RESPONSE TO REQUEST FOR ADDITIONAL INFORMATION

APR1400 Design Certification

Docket No. 52-046

RAI No.: 95-8080
SRP Section: 08.03.01 – AC Power Systems (Onsite)
Application Section: 8.3.1
Date of RAI Issue: 07/22/2015

Table 8.3.1-2 (5 of 5)

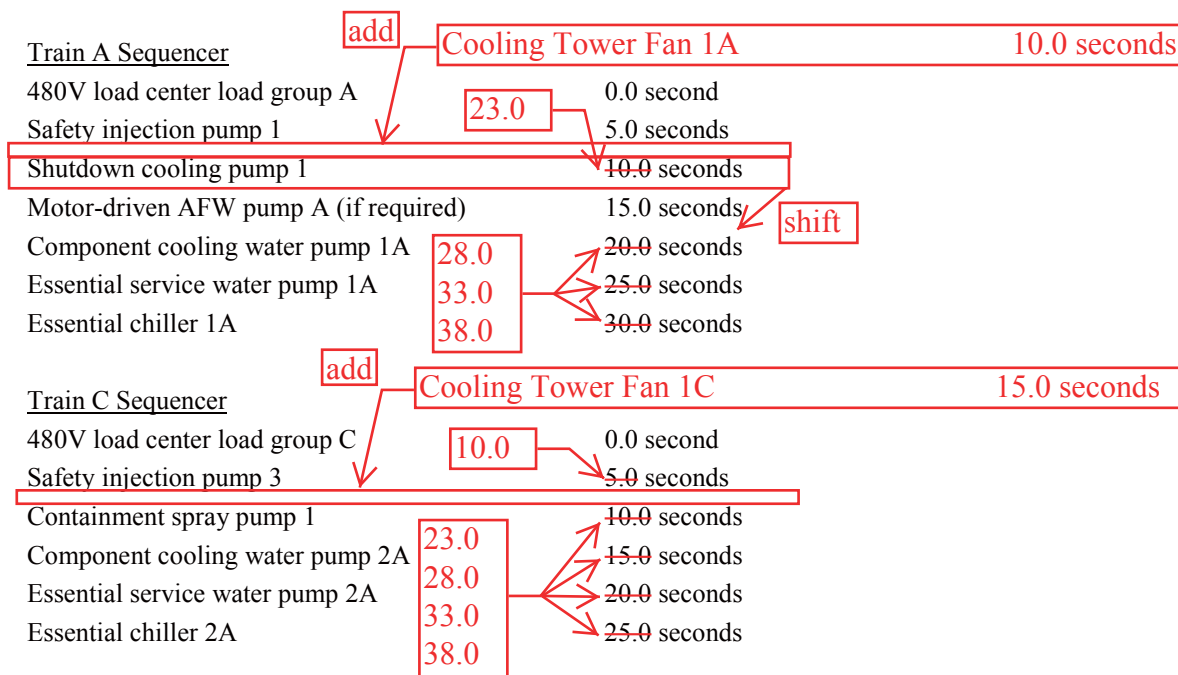
Please explain how the four Class 1E buses (trains) are functionally independent. It is noted that loading of safety buses, train A and C and train B and D, are not identical. Explain how these are not identical, and clarify if the minor variation of loading for four DGs is evaluated as acceptable for shutdown of the plant, when a divisional pair is considered for safety function/safe shut-down. Under the worst case scenario, if an EDG of the Division II is under maintenance/out of service, explain how the single failure (1 EDG fail to start) in Division I can perform the required safety functions or bring the plant to a safe shutdown.

Difference in the loading of safety buses, train A and C and train B and D

According to the updated EDG load information, the 4.16 kV load data of train A and C safety buses are identical to those of train B and D safety buses. DCD Tier 2, Table 8.3.1-2 and Table 8.3.1-3 will be updated to reflect the identical loading as shown in the attachment.

DCD Tier 2, Table 8.3.1-2 and 8.3.1-3 will be revised as shown in the Attachment.
